SB, Protective washer for carrier bearing seal, 545 Mark II, 550 XP/XPG Mark II, 2020-06

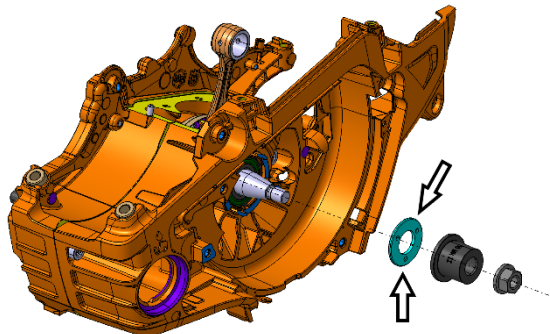
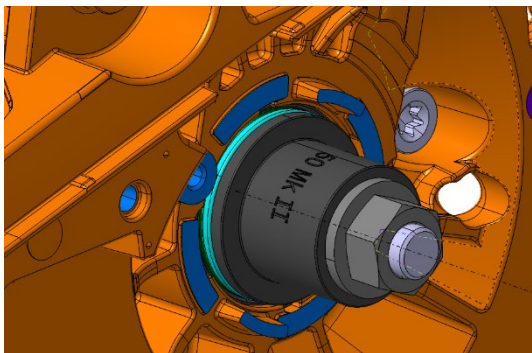
To increase durability and prevent leakage from the ball bearing sealing, a protective washer has been added on the flywheel side. There is full interchangeability.

The protective washer is mounted outside of the main bearing with the installation tool. It is important to use a torque wrench and apply 2 Nm force when assembling the washer. This is described in the Workshop Manual.

Protective washer 596 91 13-01	Installation tool 596 99 03-02
	Flywheel Nut 503 22 04-01
